CASE OFFICER'S REPORT

Application Reference:	PL/2023/07819
Site Address:	23 Milford Street, Salisbury, SP1 2AP
Date of Inspection:	09/11/23
Date site notice posted:	29/09/23
Publicity Expiry	26/10/23

Retrospective planning permission is sought for the installation of a first floor balcony serving the residential flat and the enlarging of the existing window to form a door/access. Other works include the formation of garage doors to the front of the building. The site already benefits from listed building consent PL/2022/06576 for the works subject to this scheme.

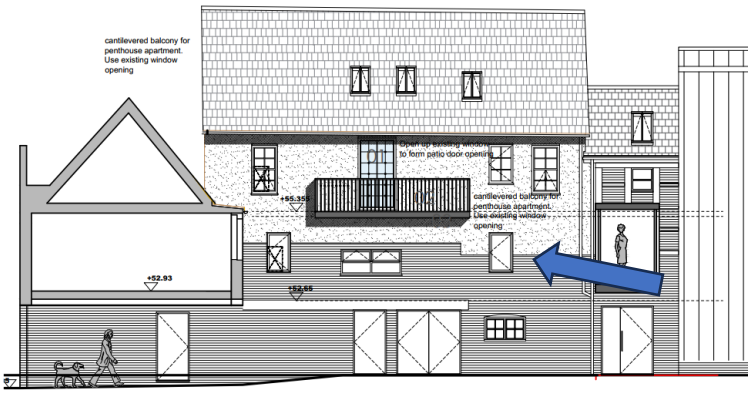
The location of the balcony is on the eastern elevation of the complex accessed via a private entrance/alleyway and is not visible when viewed from Milford Street. Concerns received refer to a lack of natural light to the largest first floor window serving the flat below. This window is denoted by the blue arrow as shown on the plan below.

Given the built form of the complex and the orientation of this window against the movement of the sun (this being from east to west), the amount of natural light received by this window would be limited and only experienced fully during early to mid-morning in the summer months. During winter months, the height of the sun would not rise much further than the roof pitch of the building complex and therefore, natural light received via this window would be non-existent. This scenario was observed during the case officer site visit to the application site and is shown in the photographs above. Whilst officers do note the introduction of the balcony may cast additional shadow at certain times of the day, this shadow or loss of natural light to the window would in the opinion of the case officer, not be sufficient to justify a refusal of planning permission.

In terms of views obtained from the second floor balcony, these would be mainly of the roof pitch of the adjacent building (a roof void associated with the commercial use of the site) within the complex and therefore, in officer opinion would not cause any significant impact in respect of overlooking onto this building or wider area.

As such, for the reasons as outlined, officers are of the opinion that there would not be any significant adverse impact to the amenity of the flat below or to the wider complex by way of the works that have been completed to warrant the refusal of planning permission.
